Technical Service Bulletin: tsb101791

Released Date: 03-Jan-2006

Cylinder Head Reuse for Update from 13-Piece to Single-Piece Cylinder Head Gasket

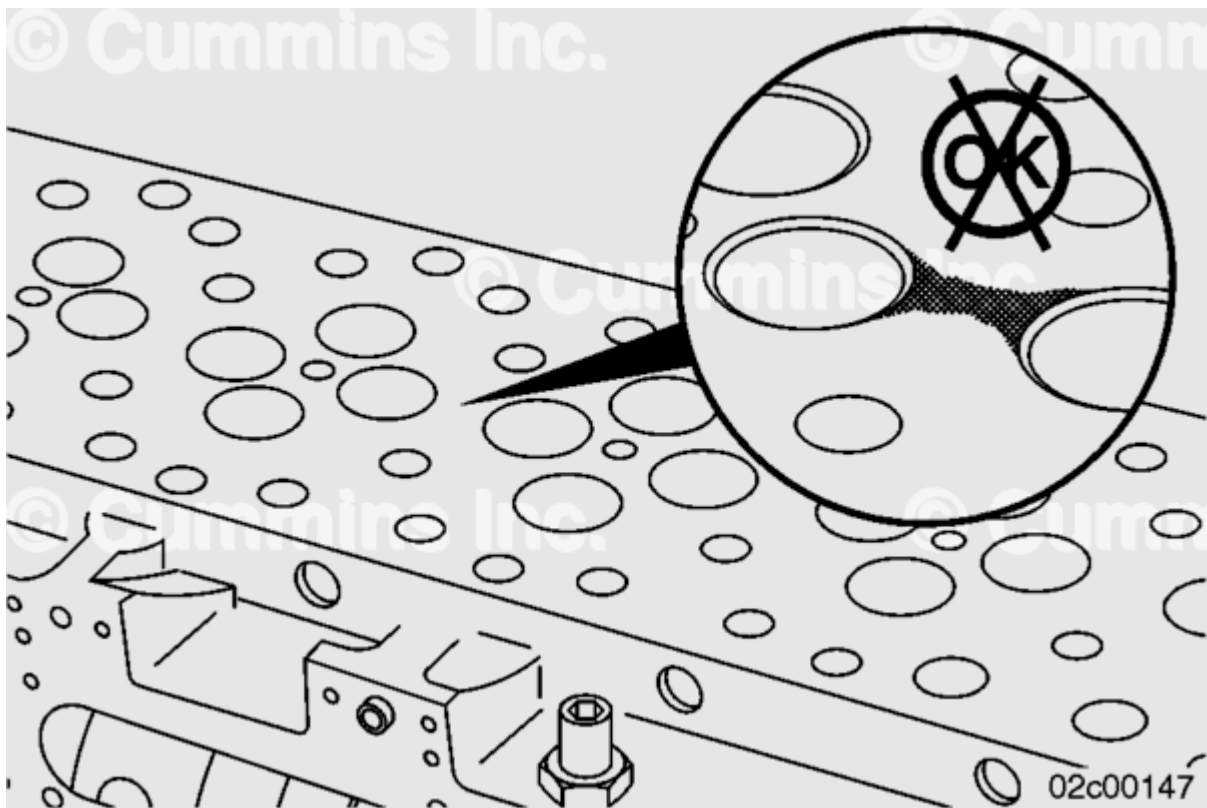
Note : Wear in the area that the fire ring combustion seal contacts the head is now acceptable when replacing a 13-piece head gasket and grooved liners with a one-piece head gasket and flattop liners.

Depth Across Sealing Area

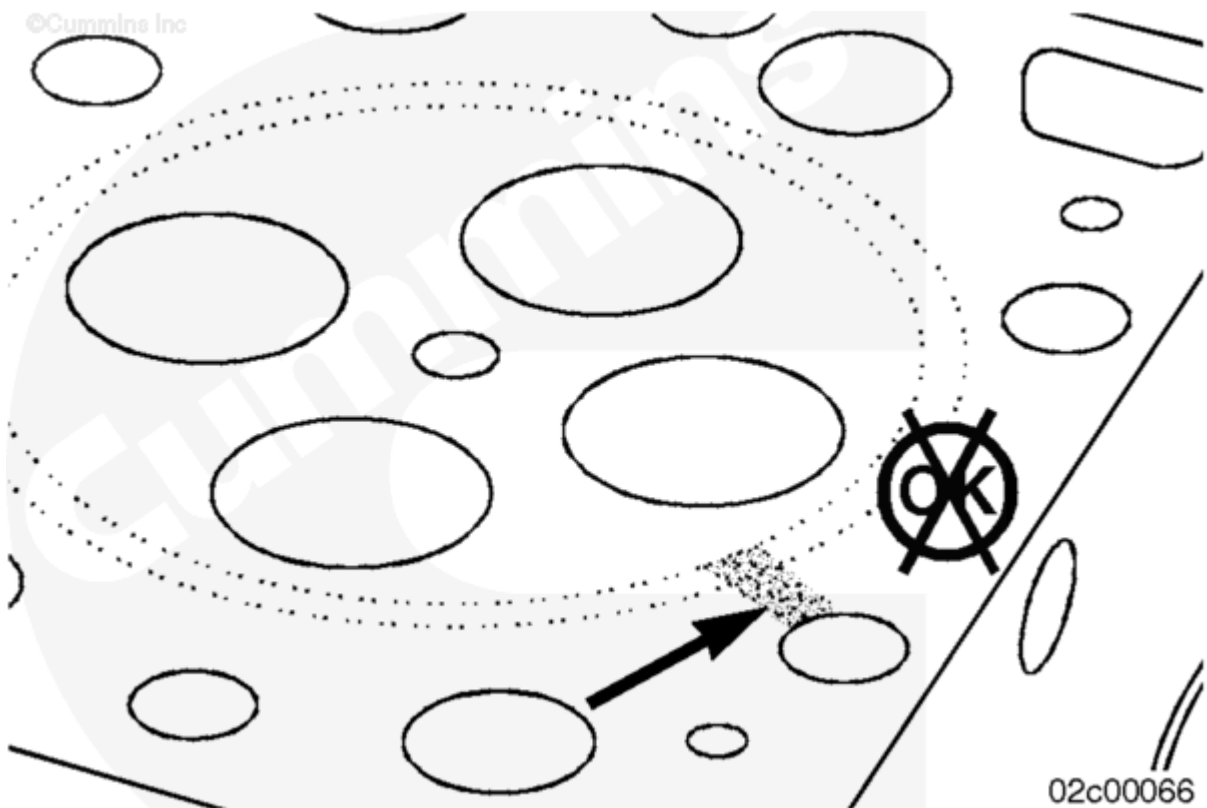
This change in Reuse Guidelines does **not** apply to instances when, after the cylinder head has been cleaned, there is detectable depth across the sealing area between two cylinders or between a cylinder and coolant passage or a cylinder and capscrew hole.
